Consulting Engineering Services, Sump Pump Amnesty Program

ADDENDUM NO. 2

March 21, 2013

SUMP PUMP RFP - SAMPLE

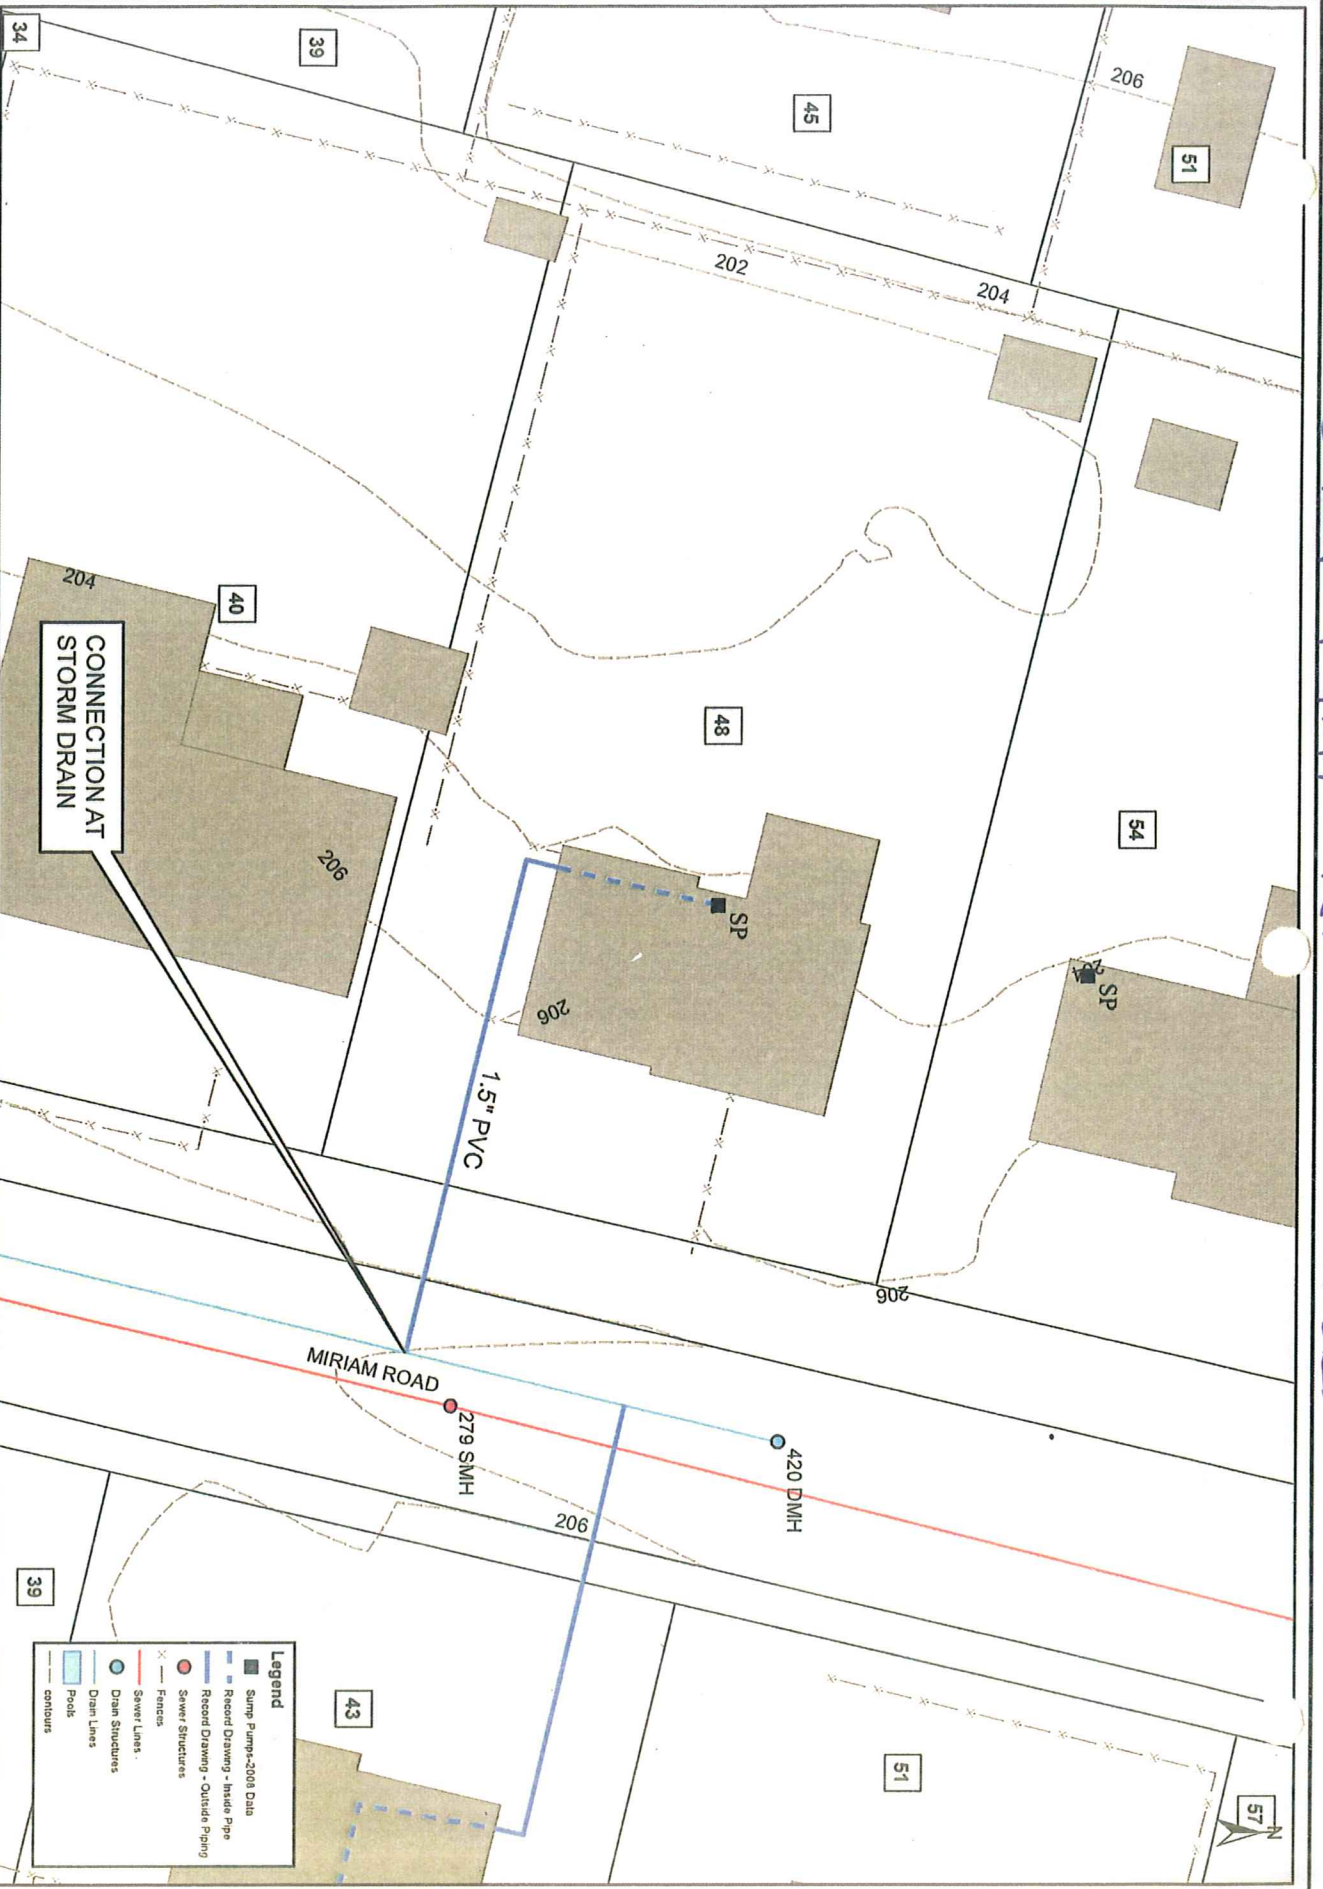
Q2. Would the City like the sewer/ storm drain tie ins, or full topo? What type of subsurface investigation is warranted?

Q3. In the Project Scope in Task 1, the RFP mentioned an attached sample (of the detailed design plan). All we got was the Map of Target Areas.

A2. See attached sample "sketch"

A3. See attached sample "sketch"
